# WINSTON & STRAWN LLP

October 15, 2010

We are writing on behalf of the three performing parties, Illinois Tool Works Inc, Kelsey-Hayes and NCR ("Respondents") to invoke the "Dispute Resolution" process as described in Section XV, paragraphs 62 through 64 of the Administrative Settlement Agreement and Order on Consent for Remedial Investigation/Feasibility Study ("ASAOC") executed August 10, 2006 and effective August 15, 2006, for the South Dayton Dump and Landfill Site, Moraine, Ohio ("Site"). We are invoking Dispute Resolution in response to the October 5, 2010 U.S. EPA correspondence requiring expansion of the Presumptive Remedy beyond the scope defined in the ASAOC. Respondents entered into the ASAOC based on the agreement with U.S. EPA that the Presumptive Remedy would be limited to capping to address the potential risk from direct contact with the landfill contents in the central portion of the Site ("Presumptive Remedy Area") and all other Site media and areas would be addressed through a conventional RI/FS. U.S. EPA's current position regarding extension of the Presumptive Remedy to media beyond the direct contact risk posed by the landfill material not only violates the

# SOIL VAPOUR RESULTS SOUTH DAYTON DUMP AND LANDFILL SITE Moraine, Ohio

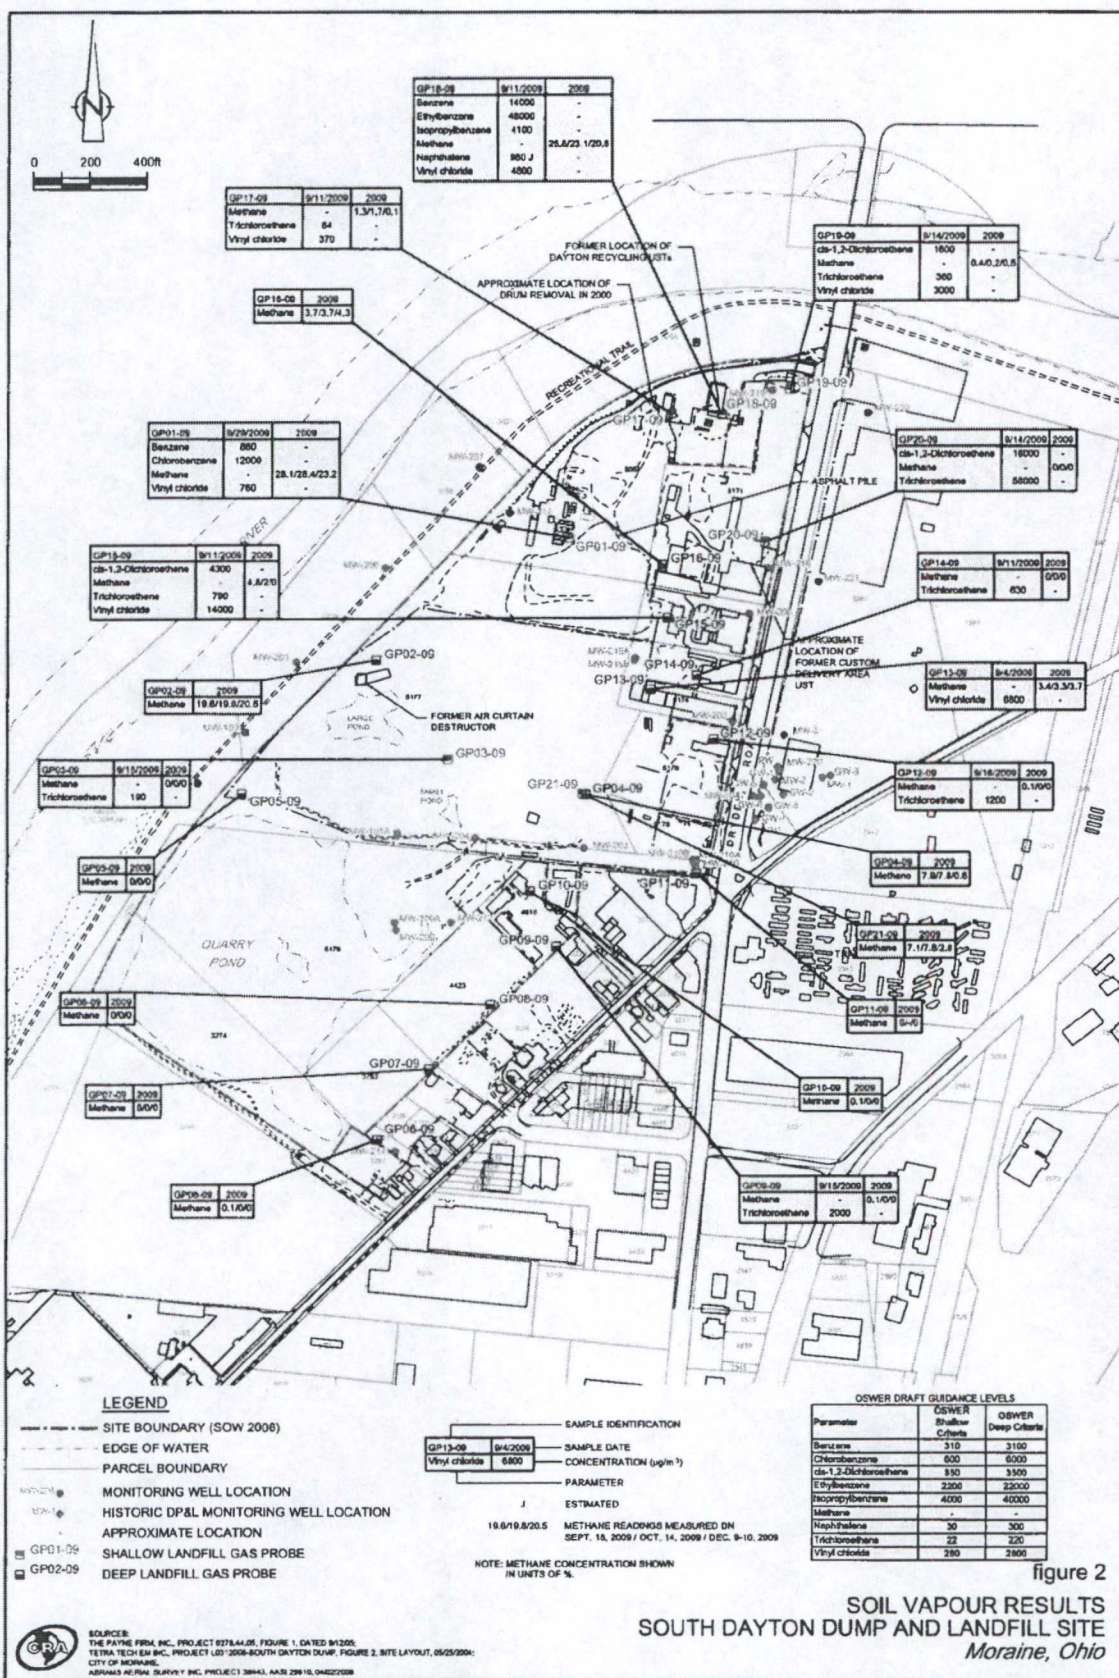
CRA's soil gas sampling also shows hazardous substances, including vinyl chloride and trichloroethene, are present above  $10^{-4}$  risk levels at 11 out of 21 gas probe locations (see Figure 2 in Attachment 3), and are present above  $10^{-5}$  or  $10^{-6}$  risk levels at 8 other locations.

CRA's 2009 soil gas data also indicates the widespread presence of chlorinated solvents at the Site. Vinyl chloride was detected above OSWER  $10^{-4}$  soil vapor criteria (non-conservative) at 6 out of 21 on-Site soil gas probe locations (see Figure 2 in Attachment 3). TCE was detected above  $10^{-4}$  soil vapor criteria (non-conservative) at 8 out of 21 on-Site gas probe locations. Cis-1,2-DCE was also detected above OSWER soil vapor criteria equal to a hazard index of 1 at three on-Site gas probe locations. Chlorinated solvents were detected above more conservative OSWER soil vapor criteria ( $10^{-5}$  or  $10^{-6}$  cancer risk) at eight other locations; making chlorinated solvents present in 19 out of 21 on-Site gas probe locations.

CRA's 2009 soil gas data also indicates the widespread presence of benzene at the Site. Benzene was detected above OSWER  $10^{-4}$  soil vapor criteria (non-conservative) at two on-Site soil gas probe locations (GP01-09 and GP18-09) (see Figure 2 in Attachment 3). Benzene was detected above more conservative OSWER  $10^{-5}$  or  $10^{-6}$  soil gas criteria at five other on-Site locations (GP02-09, GP04-09, GP15-09, GP17-09, GP19-09 and GP21-09). Benzene was also detected in on-Site soil gas at 8 other

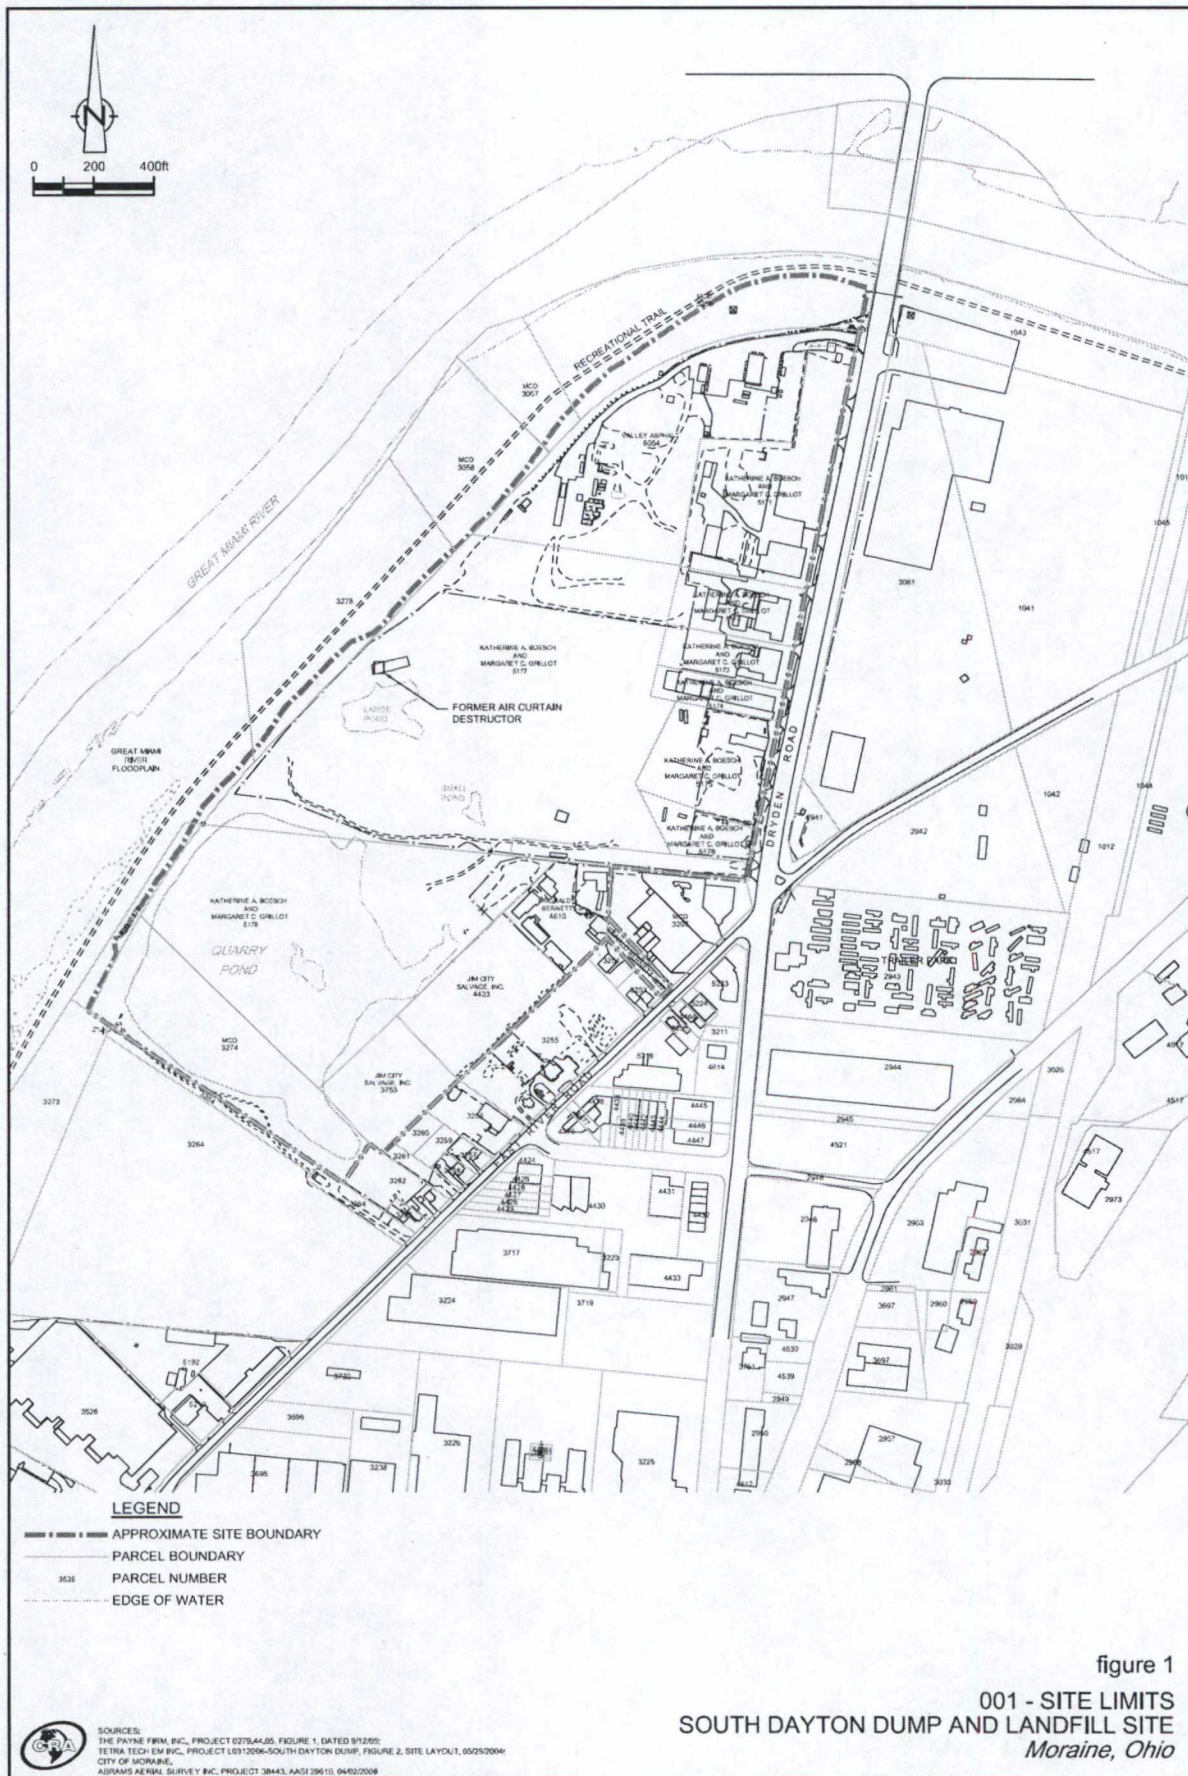
OU1 comprises the Site as defined in the ASAOC as well as certain adjacent parcels upon which waste was placed by the Site operators. As discussed in the meeting, OU1 includes the Quarry Pond. Specifically, OU1 includes the following parcels (see attached Figure 1):

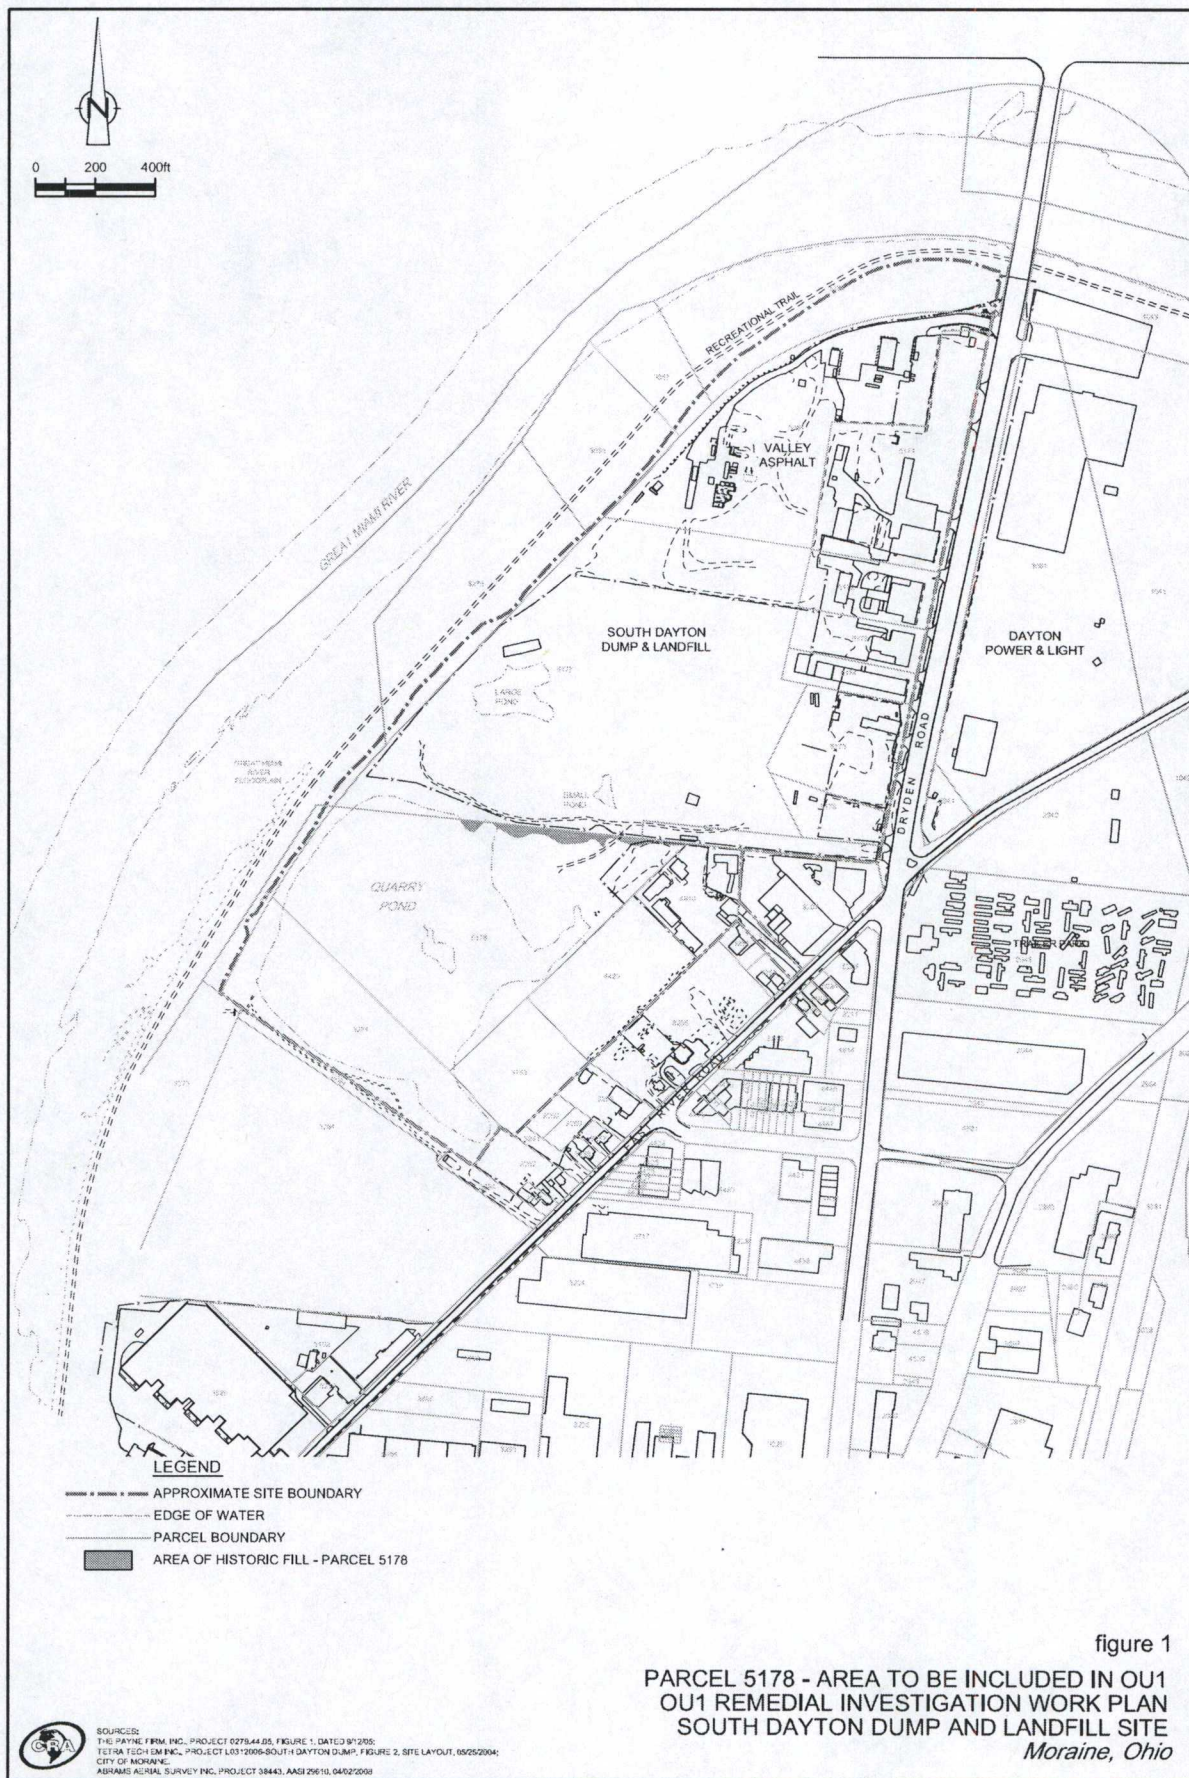
The Respondents appreciate USEPA's willingness to consider addressing the southern portion of the Site (i.e., Parcels 3252, 3274, 3275, 3753, 4423, 4610, and 5178) as part of OU2, as originally contemplated in the ASAOC. The Respondents agree that where the steep embankment marking the southern edge of the disposal area extends onto Parcel 5178 (as shown approximately on the attached Figure 1), these portions of Parcel 5178 will be addressed as part of OU1.
